# **US-APWR I&C Design Certification**

## **References Review**

Royce D. Beacom  
Instrumentation, Controls and Electrical Engineering Branch (ICE1)  
Office of New Reactors

Wednesday, February 3, 2010

Table 4.1-3 FMEA for Gr.3 controller, SLS Train A (8/8)

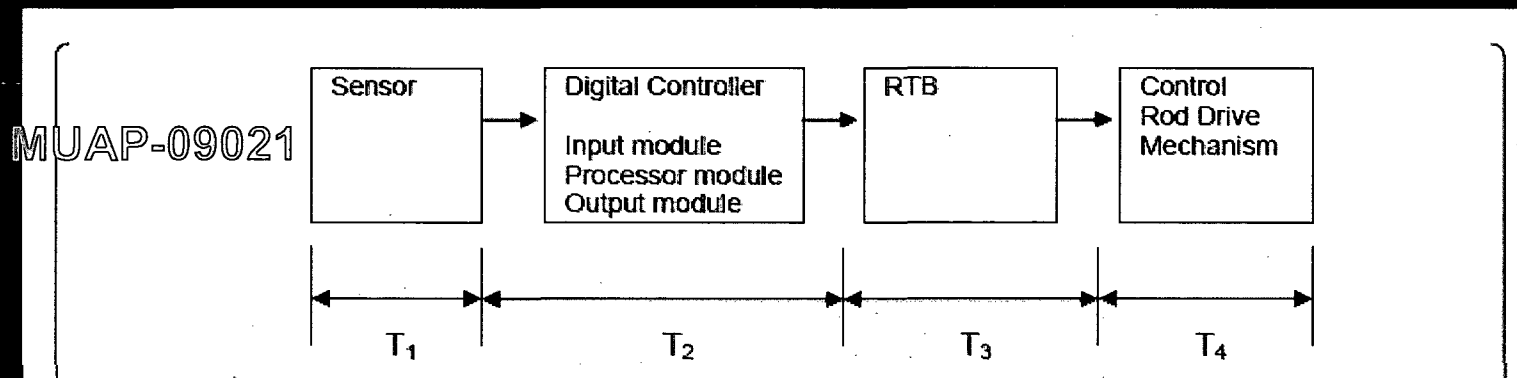
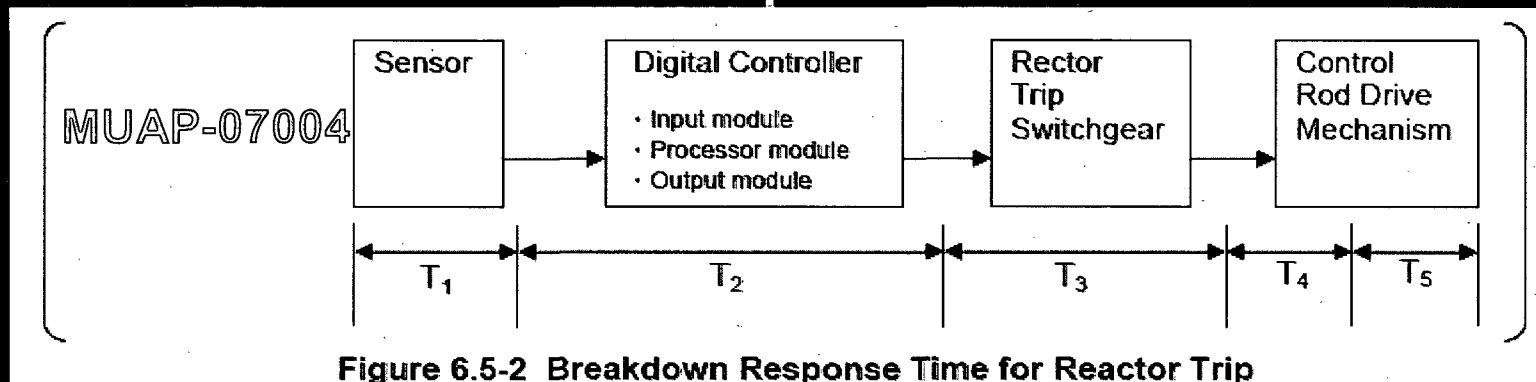
- Does not follow IEEE standards and does not evaluate I&C component failures or identify the modes of these failures, and the effects of these failures
- Suggest revision of this technical report and resubmit for review
